STAGE Case Study (Commentary and Images)

STAGE reviews within design development

Project: Demolition and New Build

Sector: Further Education

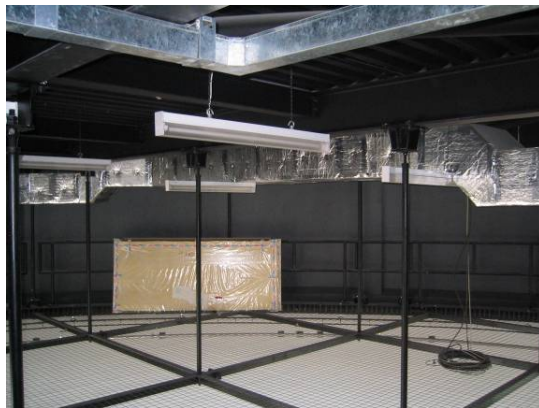
- Trapeze area weight restrictions were confirmed, accessed and communicated to the contractors and final end users.

- Communication of residual hazards connected to this system was considered during STAGE 3 review.
- Residual risks (drop hazards, weight loading and service/ maintenance needs) were communicated post STAGE review, via the H&S register to the contactor via H&S Plans and the End User via the H&S File.
